BMP NUMBER: PC200

**Stormwater Management/BMP Record Drawing and Construction Certification Review
Tracking Form**

**NEW TOWN
BLOCK 6&7 (JCC-SP-102 -04)
MOVIE THEATER (JCC-SP-103 -04)**

ENVIRONMENTAL DIVISION REVIEW COMMENTS
NEW TOWN BLOCK 6 & 7 / NEW TOWN MOVIE THEATRE
COUNTY PLAN NOS. SP - 102 - 04 / SP - 103 - 04

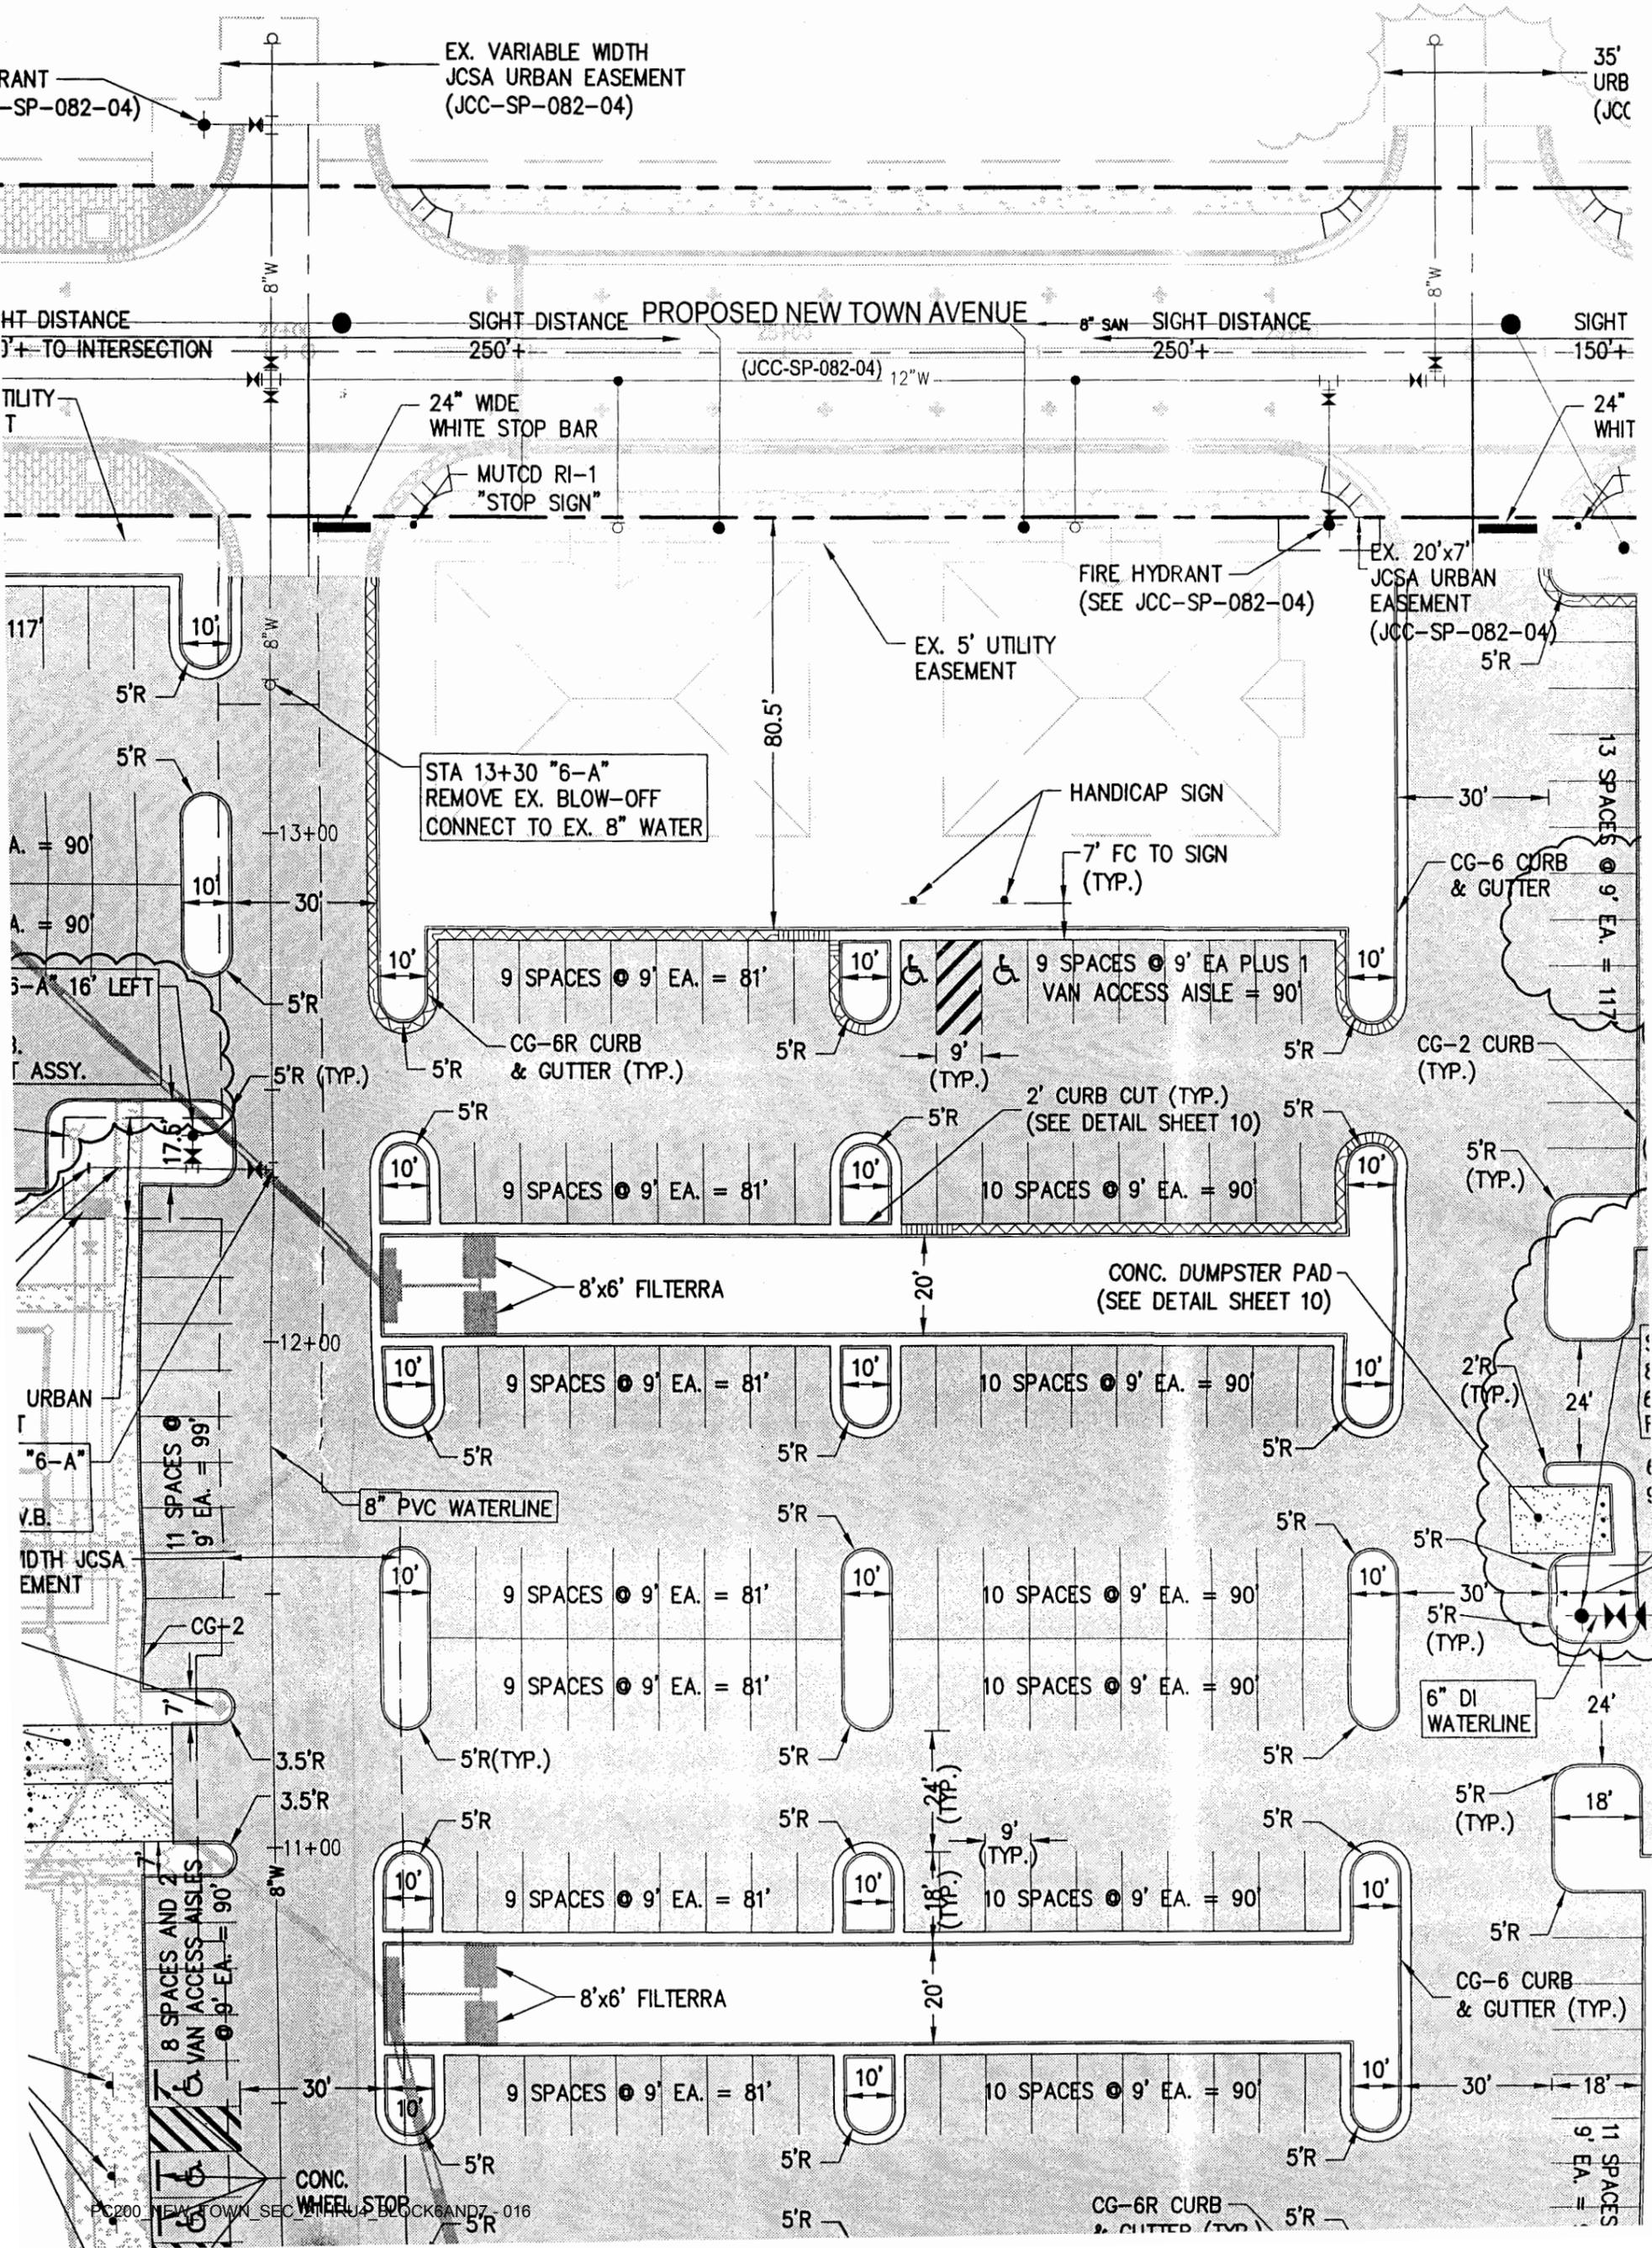
For the storm piping, response acknowledged. I am still worried about the Filterras. Based on information I have from Filterra (ie. Quick Sizing table) for a 6 x 8 box or an 8 x 6 box the total contributing drainage area is 0.26 to 0.33 acres. For the two 8 x 6 which handle drainage from the new parking area (toward Discovery), it would appear that drainage area to either of the two boxes is well more than 0.33 acres. Based on rough scaling of the grading/drainage plan, it would appear that drainage area to each of the boxes is about double that.

8. Manufactured BMPs. The use of four (4) bioretention tree box units are indicated on Sheet 5. Provide a specific maintenance plan for the BMP units, or at a minimum, provide a note referencing manufacturer's recommendations and Minimum Standard & Spec. 3.11 C of the VSMH for maintenance. (*Note: A maintenance plan is required for all BMPs per the Chesapeake Bay Preservation ordinance.*)

As discussed Thursday March 10, the shape of the drainage area associated with the Filterra and Storm Drain inlets do change slightly; however for area of the parking lot that was added, an equal amount of building area was removed. The "C" Factor remains consistent based on the area served. The Filterras continue to have an adequate drainage area for each inlet in accordance with Americast

sheet 10

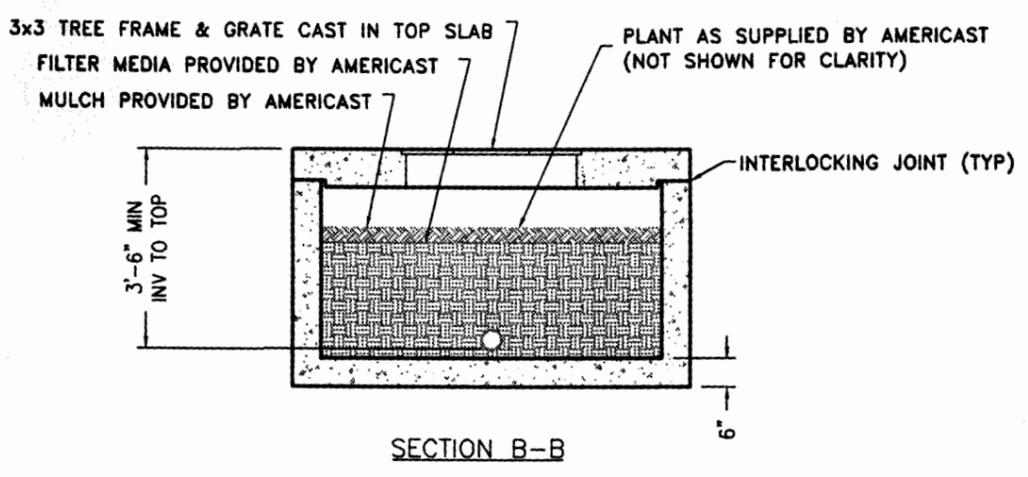
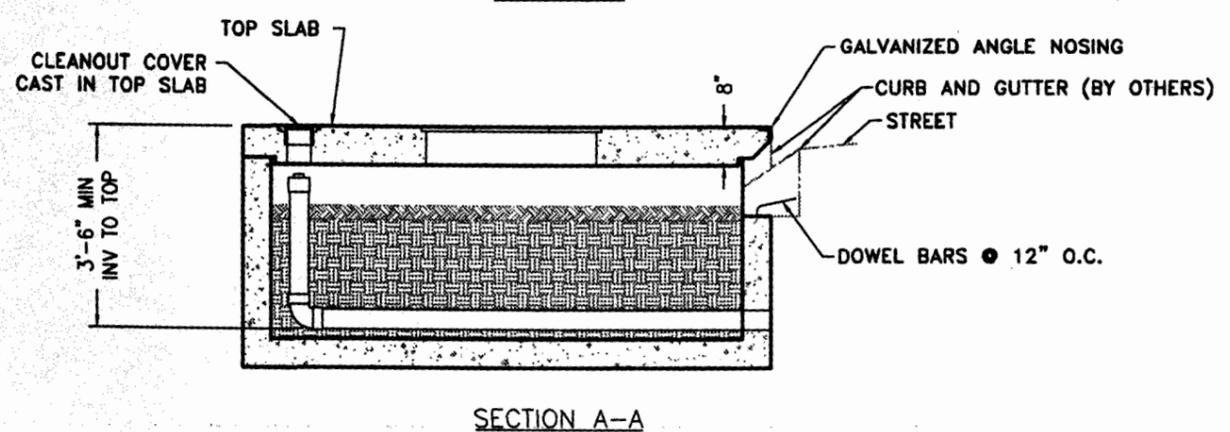
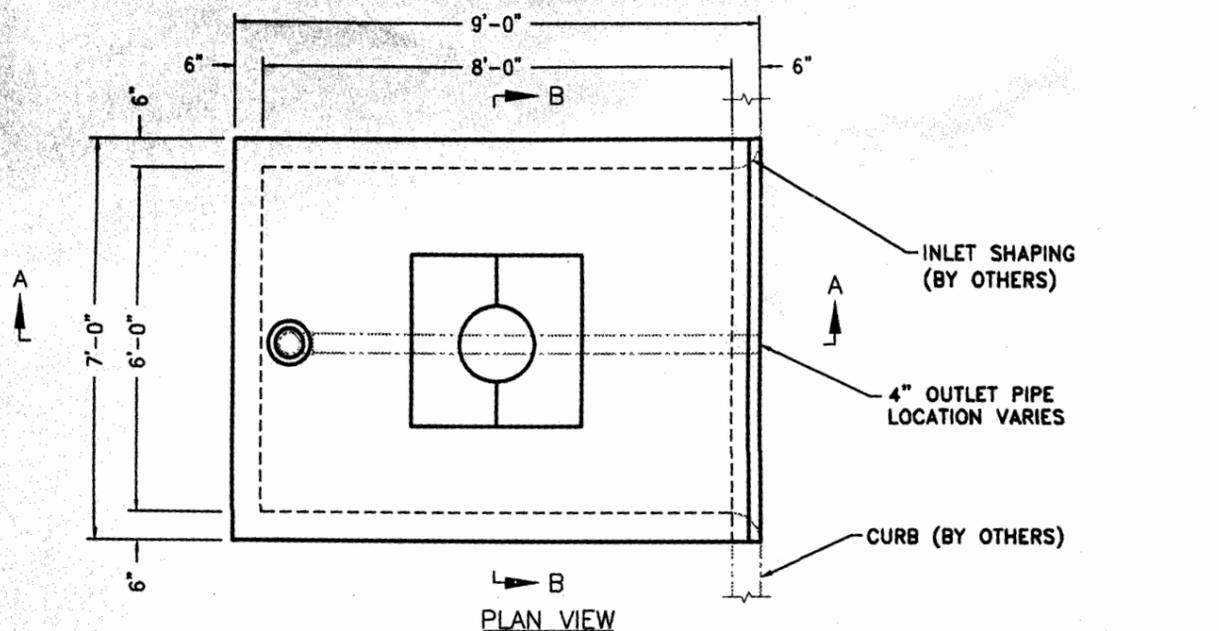
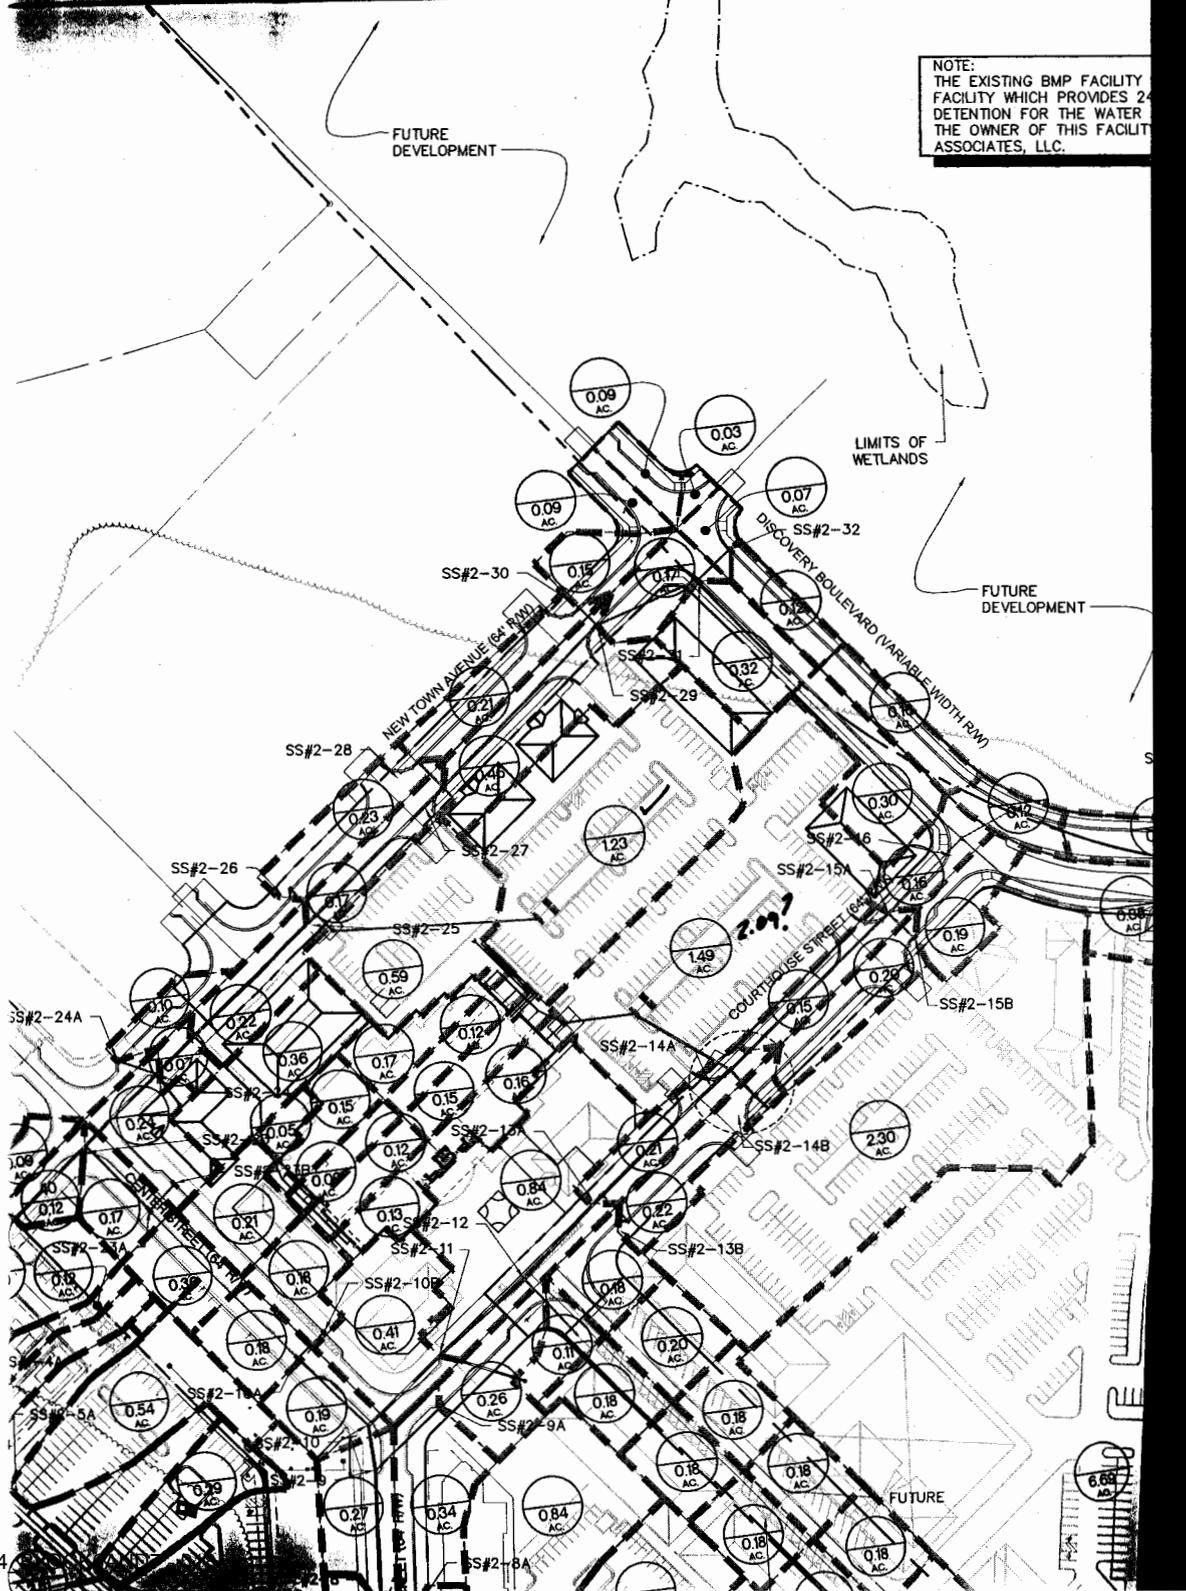
3. Record Drawing and Construction Certification. The stormwater management/BMP facilities as proposed for this project (bioretention filter boxes) will require submission, review and approval of a record drawing (as-built) and construction certification prior to release of the posted bond/surety. Provide notes on the plan accordingly to ensure this activity is adequately coordinated and performed before, during and following construction in accordance with current County guidelines.

8. Manufactured BMPs. The use of four (4) bioretention tree box units are indicated on Sheet 5. Provide a specific maintenance plan for the BMP units, or at a minimum, provide a note referencing manufacturer's recommendations and Minimum Standard & Spec. 3.11 C of the VSMH for maintenance. (*Note: A maintenance plan is required for all BMPs per the Chesapeake Bay Preservation ordinance.*)
Note indicating maintenance of the Filterra units in accordance with Manufacturer's Recommendations and Minimum Standards is included on Sheet 10.

A note has been added to Sheet 10.
